**APPENDIX V**  
**RESPONSIVENESS SUMMARY**

**RESPONSIVENESS SUMMARY  
FOR THE  
RECORD OF DECISION  
RIVERSIDE INDUSTRIAL PARK SUPERFUND SITE  
NEWARK, NEW JERSEY**

Figure 2: PPG paint manufacturing plant in City of Newark, New Jersey (Exhibit 10.B to EPA's September 4, 2020 Statement of Position).

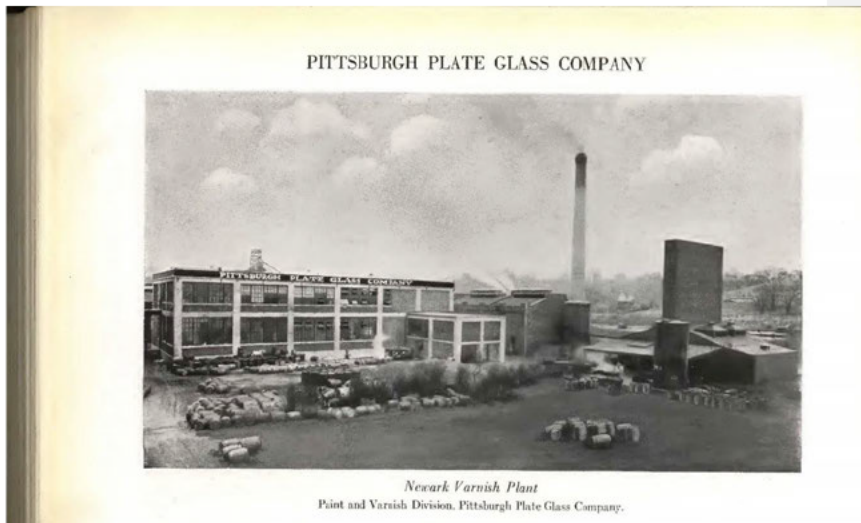
1. Comment: A commenter stated that EPA's Conceptual Site Model (CSM) is flawed. The commenter indicated that the ~~proposed remedy~~ Proposed Plan is based on the assumption of a "top down" CSM, which ignores information presented in the RI and FS. The commenter stated that EPA's CSM does not consider the historic fill as the primary, if not sole, source of lead in groundwater. The commenter stated that EPA's CSM is based on the assumption that historical releases from Site operations contaminated the soil, which in turn migrated to groundwater. The commenter indicated that the impervious surfaces of the Site would have prevented any spills or releases from Site activities from impacting the soil, and any lead that might have reached the soil is likely to be immobile. The commenter also argues that the 'hinged flappers' spaced along the base of the exterior walls in certain buildings were components of standard fire water management systems and were not for the discharge of waste. The commenter believes that historic fill is the source of lead in groundwater, and not the historical spills and/or releases of paint and other materials containing lead that are the basis of EPA's CSM.

Response: EPA's CSM is consistent with the data presented in the RI Report (April 2020). Both the Site data and evidence about historical Site operations support the Region's determination that former lead paint manufacturing operations at the Site contributed the predominant source of lead contamination to the soil and groundwater. From approximately 1902 to 1971, the Site was used for paint, varnish, linseed oil, and resin manufacturing by Patton Paint Company ("Patton"), which merged into the Paint and Varnish Division of Pittsburgh Plate Glass Company in 1920. Pittsburgh Plate Glass Company changed its name to PPG Industries, Inc. in 1968. PPG conveyed its interest in the Site in 1971. The RI Report (April 2020) states on page 1-3 that "Pigments would have been brought to the Site and used in the manufacture of paints. These were often metallic chemicals and would have included compounds of cadmium, chromium, lead, titanium, and zinc. Basic lead carbonate (white lead) would have been one of the pigments used as a raw material." This statement is consistent with the following two historical references to the use of basic lead carbonate on the Site, which are part of the record of the dispute resolution proceeding, included in the administrative record for the Site:

A photograph of the Patton facility from the book "Glass, Paints, Varnishes and Brushes, Their History, Manufacture and Use (copyright 1923 Pittsburgh Plate Glass Company)" (Figure 2) depicts Building #9 and Building #6 (looking northeast) on page 24 of its "Paint Section." Building #7A is also shown on the right side of the cited picture; Building #7A would eventually be replaced by the current Building #7. Note that barrels and various materials are stored on the ground in front of the buildings. These buildings border Lot 63/64, where the focused lead removal will occur and Building #7 is on Lot 63. (Note that Lot 63 is one of 15 lots on the Site, and the RI Report includes information regarding Site operations for each lot [RI Report, pages 1-3 through 1-30]).

The historic use of large quantities of lead in the production of paint at this Site and PPG's documented housekeeping practices support EPA's determination in the CSM that historical ~~Site~~ operations released lead into soil/fill at the Site.

Figure 3: Lead and Zinc Correlation in Soil/Fill Material from Riverside (Exhibit 13 from EPA's September 4, 2020 Statement of Position)

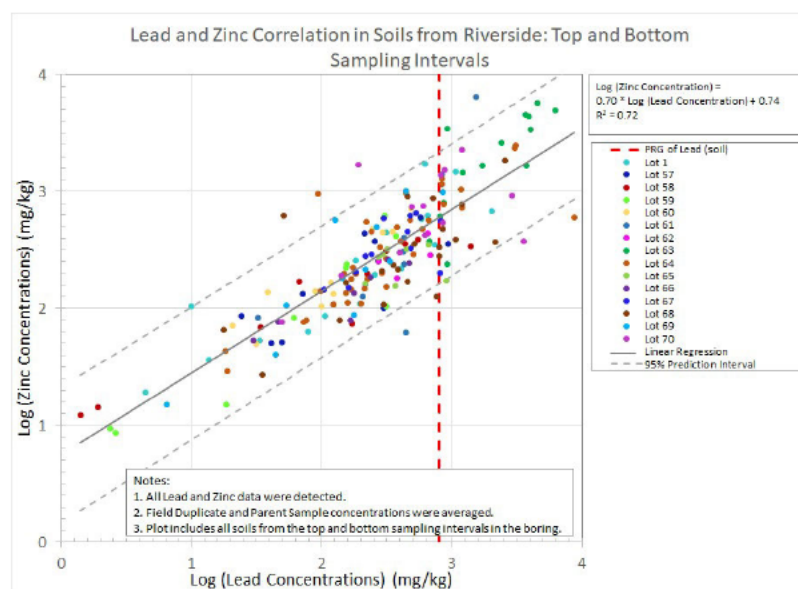
2. Comment: A commenter indicated that if EPA's CSM were accurate and the lead in soil and groundwater at the Site resulted from spills and/or releases from historical facility operations, including paint manufacturing, there would be a correlation between lead and other metals found in paint. The commenter argues that the correlation between lead and zinc does not support EPA's assertion that lead in soil/fill is from historical Site operations.

Response: The historic facility operations support the conclusion that lead and zinc were released into the soil/fill material as a result of paint and varnish plant

housekeeping activities, along with incidental releases of white lead and zinc oxide pigments during material storage, handling, and transfer. The likelihood that PPG operations are a source of lead contamination in Site soil also is supported by a positive correlation between lead and zinc in the soil/fill material samples collected during the RI, with a linear regression coefficient of  $R^2$  of 0.72. The highest levels of lead in the RI borings are reported on Lots 63 and 64 and are correlated with the highest levels of zinc (*see* the cluster of green and light brown points on the right side of Figure 3, ~~below~~), strongly suggesting that historical facility operations are a primary source of lead and zinc at these locations.

Figure 4: Figure A-3 from FS Report (July 2020) Appendix A showing delineated areas of lead in soil/fill material that exceed the remediation goal (RG) of 800 mg/kg and the footprint of lead removal around Building #7, which is part of EPA's Preferred Alternative for soil/fill material.

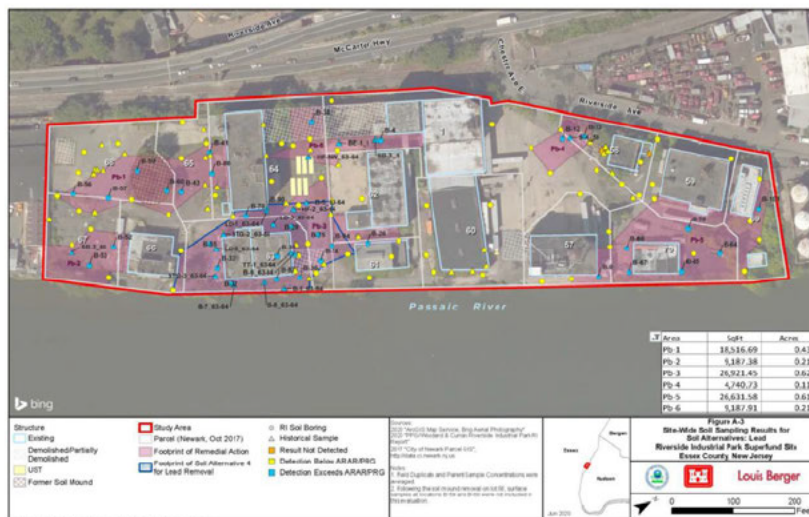
3. Comment: A commenter stated that EPA's CSM is based on lead in soil being the source of lead in groundwater and that for this to be an accurate CSM, the lead in surface soil should correlate to lead in subsurface soil and to lead in groundwater, and the commenter suggests the data do not follow this pattern. The commenter ~~indicates-states~~ that the lack of a point-by-point correlation between lead in soil and lead in groundwater undermines EPA's CSM. The commenter also criticized EPA's CSM by presenting an analysis of groundwater data that included grouping the monitoring wells based on locations in the northern portion of the Site, the southern portion of the Site, and the monitoring wells on Lot 63. The commenter concluded from ~~their-its~~ analysis that the distribution of lead in groundwater is not consistent with EPA's CSM.

Response: The commenter incorrectly asserts that there is no spatial correlation

between lead levels in soil and elevated total lead levels in groundwater. A point-by-point spatial correlation between soil/fill material sample results and groundwater results cannot be undertaken at the Site because of the various groundwater gradients across the Site and lack of co-located samples. Co-located soil/fill material samples and shallow groundwater samples were mainly collected from the temporary well points; however, it was agreed between Region 2 and PPG during the scoping of the remedial investigation field work that these samples would be unvalidated screening samples that would be used only to design the monitoring well network. Consequently, no single soil sample can be used to evaluate the presence or absence of total lead exceedances in a co-located groundwater sample. Instead of using a point-by-point analysis, EPA determined that the cluster of soil/fill material exceedances around the perimeter of Building #7 represents the result of lead contamination related to historical PPG activities in that portion of the Site, and the consistent exceedances of total lead in groundwater samples collected from around Building #7 are consistent with the presence of a Site-related source of lead in soils. (See Figure 4, below). Other clusters of soil exceedances are observed across the Site, particularly on Lot 70.
